**Historic Landmarks and Preservation  
Districts Commission**

**Report of the Architectural  
Review Committee**

**Case No:** 13COA1158-CL (COA)  
**Classification:** Staff Review

**Property Address:** 149 William Street

1 SOUTH ELEVATION  
Scale: 1/4" = 1'-0"

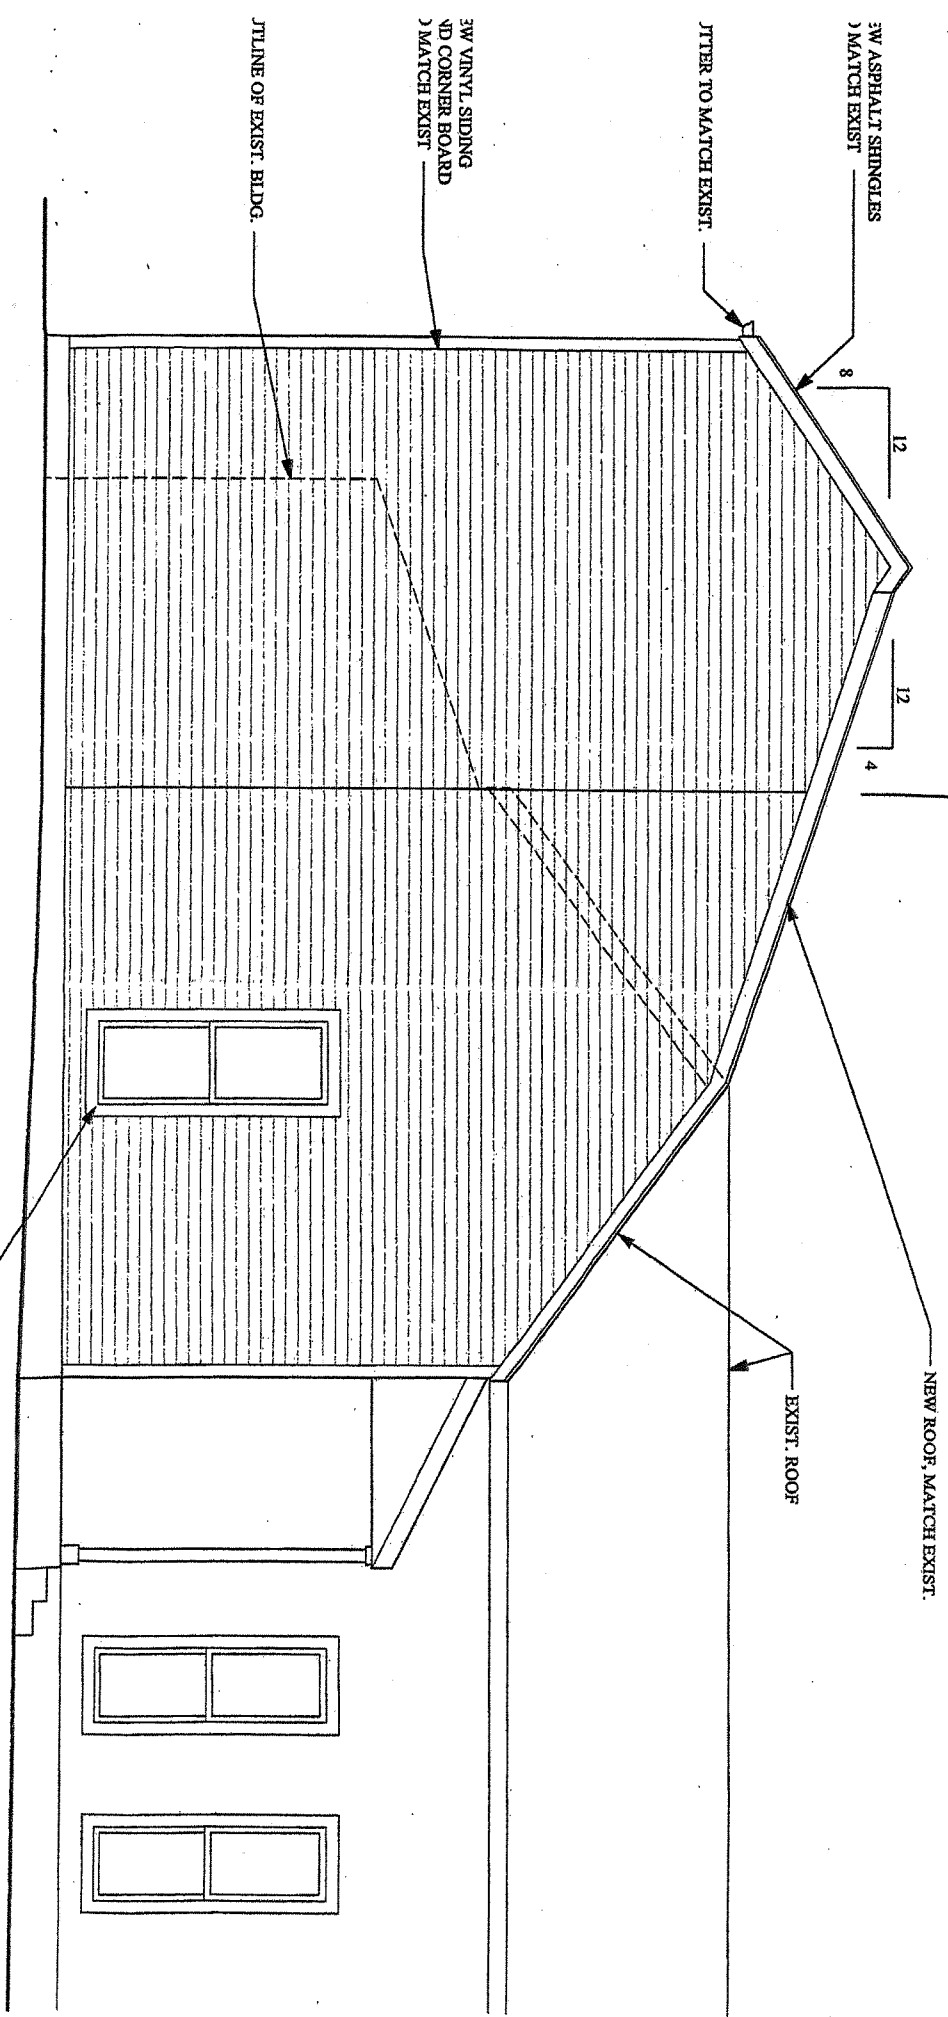
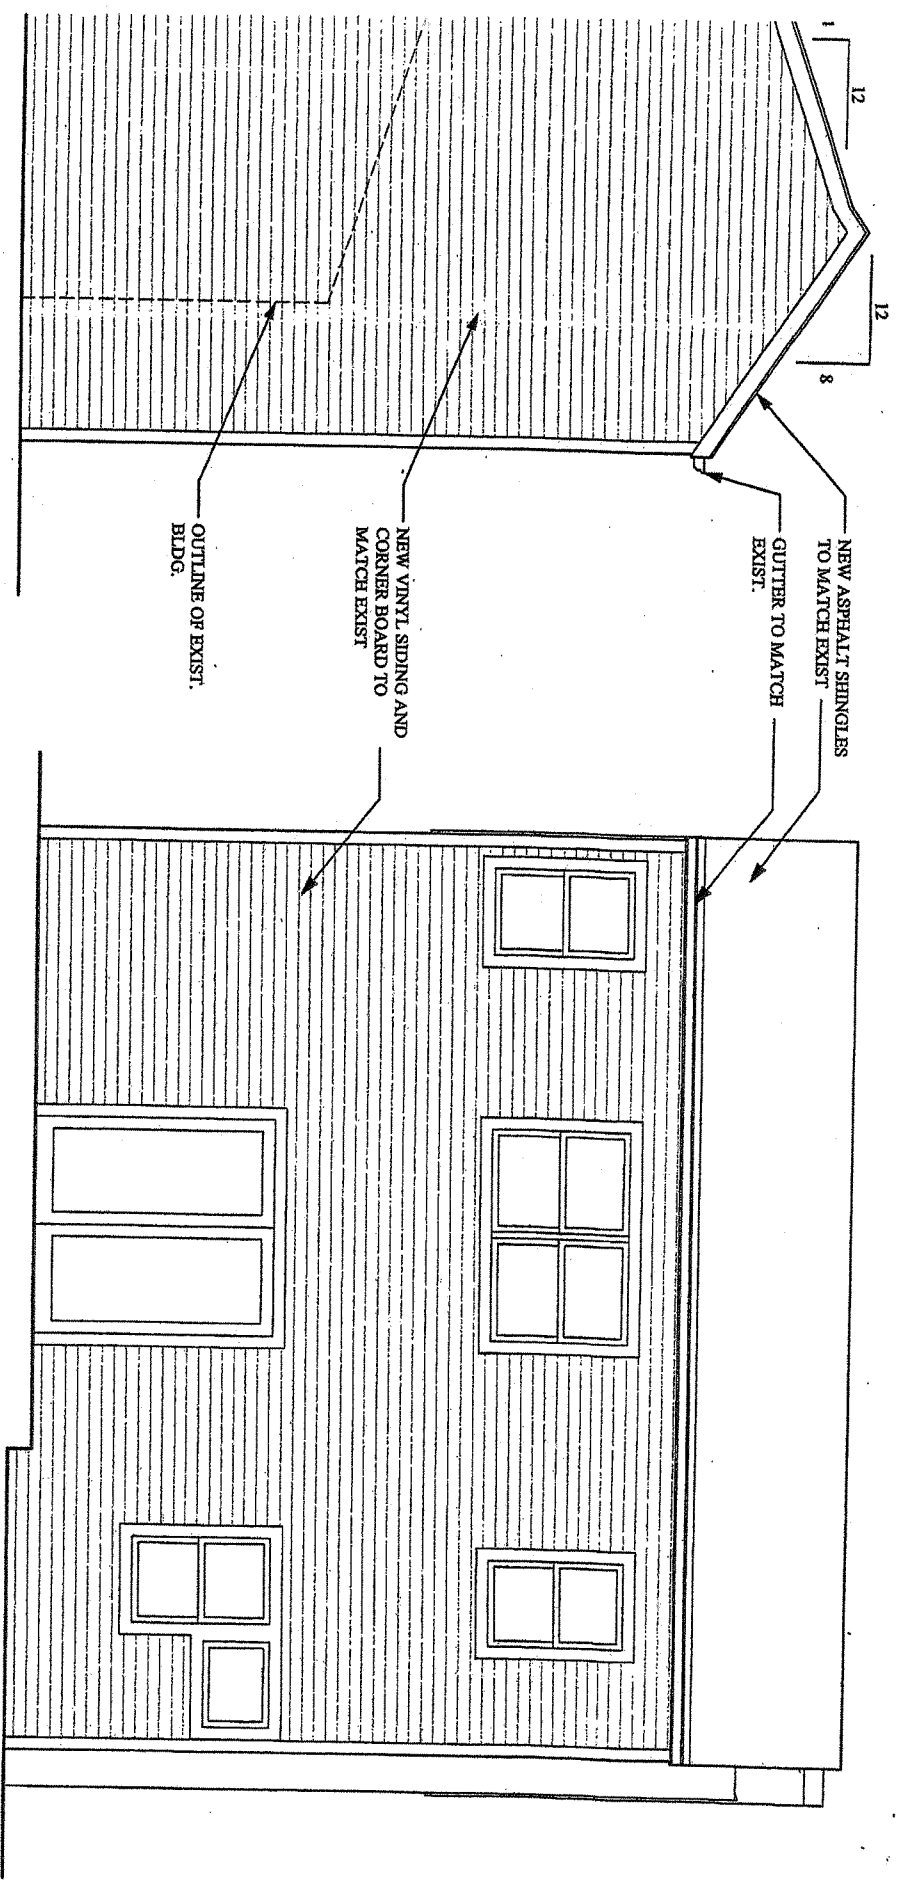
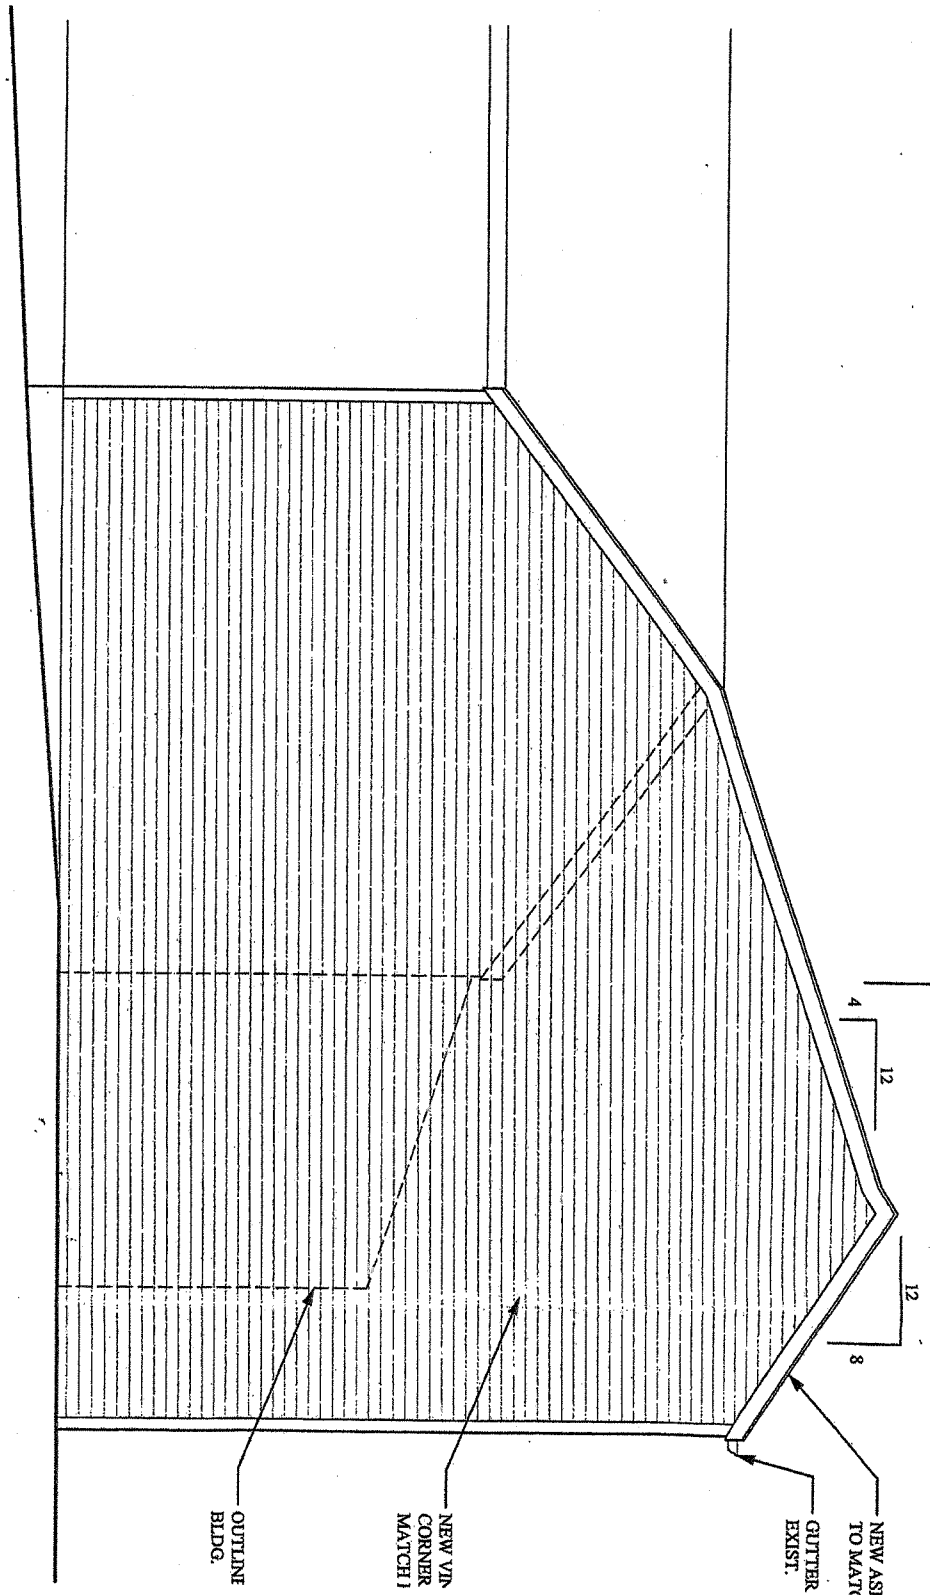
Mr. Kremer then asked why the roof ridgeline has a strange bump at the top. He thought it was a 'weird condition' that exposes the roof edges more than it should. He advised the client to talk with his architect about it. As drawn, it exposes more than hides the expanded roof ridgeline. The discussion then shifted to the north side windows on the 1<sup>st</sup> & 2<sup>nd</sup> floors (because of the façade being so close to property line, applicant should also talk with his architect about window size calculations under Residential 1 & 2-Family Building Code). The applicant also wanted a window or two on the side elevation. Staff stated that the

8. That additional windows units are proposed for building sides and rear – with single bathroom window moved to 1<sup>st</sup> floor north, and small double-hung above it on second floor north.

7. That construction is executed according to drawings submitted by Ted Bressoud Architect, and date stamped December 16, 2013 **(with corrections as noted in submitted Staff Drawing, for ridgeline edge change to roof, and to return to Staff for Approval)..**
